Location Address: 1225 N17th CT

Explanation of Request: SITE PLAN APPROVAL OF A 15 UNIT RESIDENTIAL DEVELOPMENT

PRELIMINARY TAC RESPONSE TO COMMENTS

ARTHUR STREET APARTMENTS
1225 N 17th CT
HOLLYWOOD, FL 33020

**TYPICAL FLOOR
PLAN (LEVELS
2-4)**

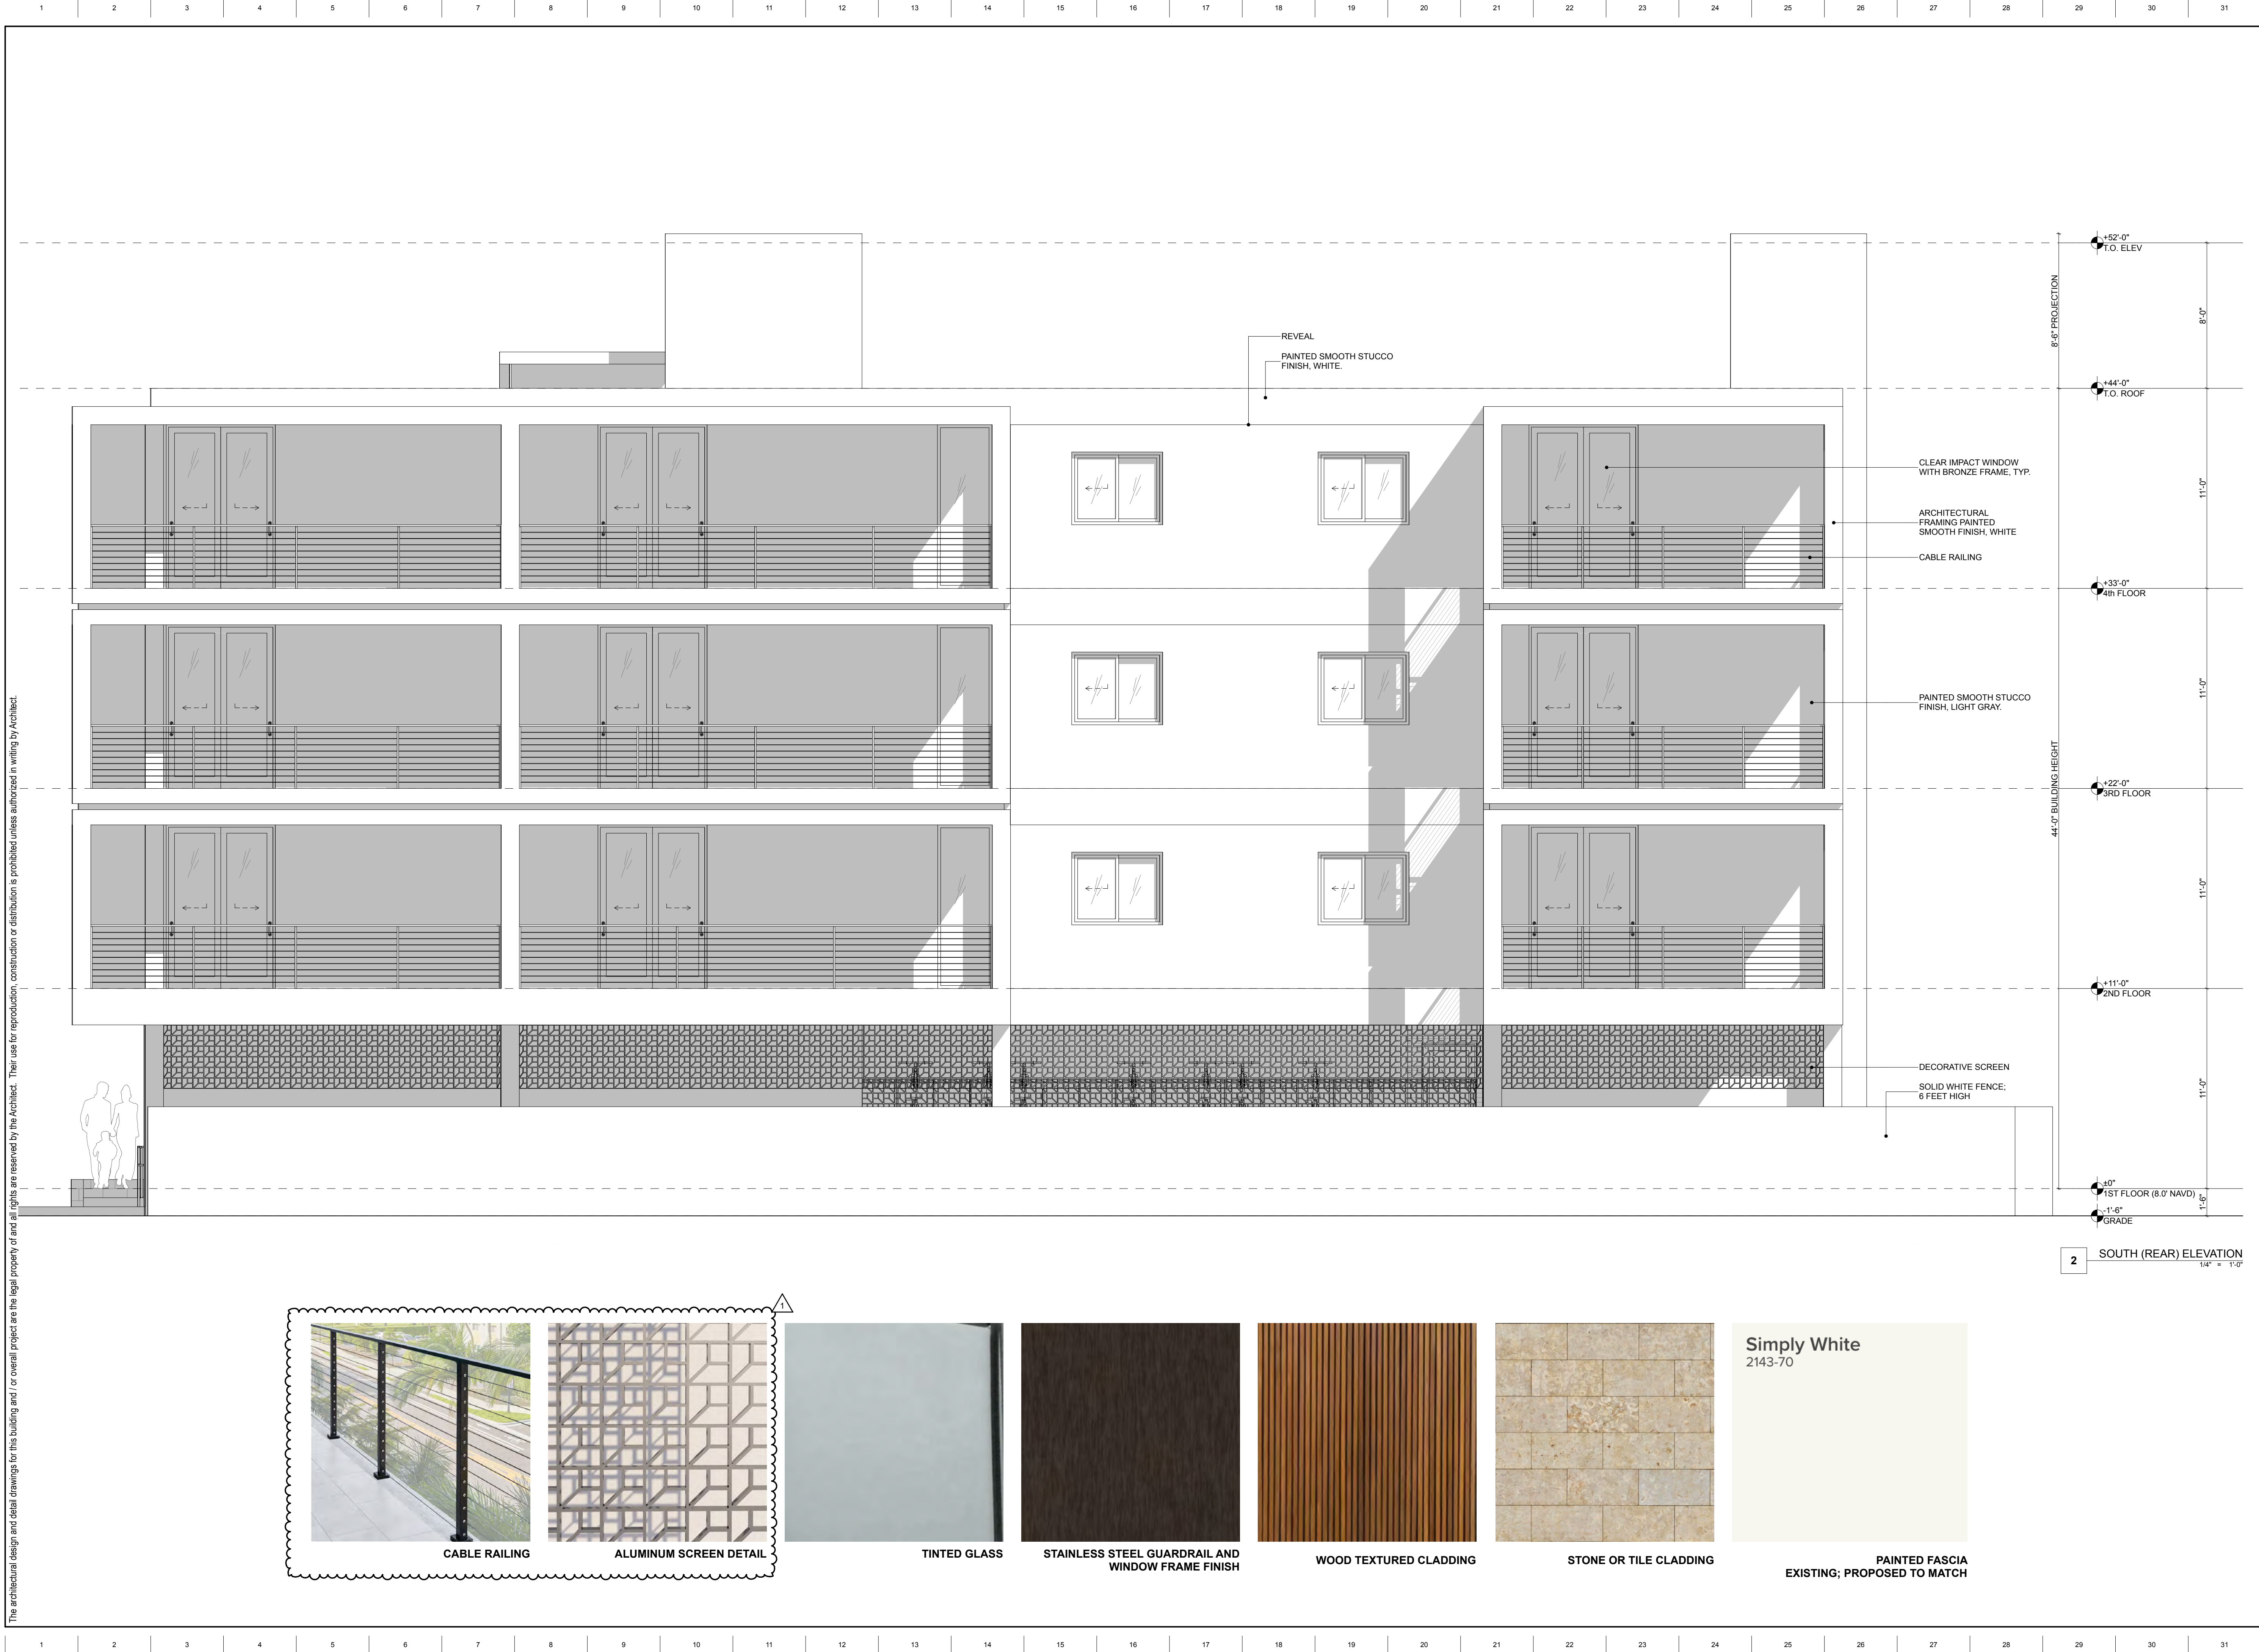
RESPONSE: Non-vehicular use area in parking lot that is not separated by type D curb is shown on floor plans sheet A001.
24. Please provide a trash chute for the garbage room.

RESPONSE: Trash chute provided. See Typical Floor on sheet A101. Trash chute is adjacent to Stair 02.
25. Please dimension all BOH areas (i.e., storage, electric etc.).
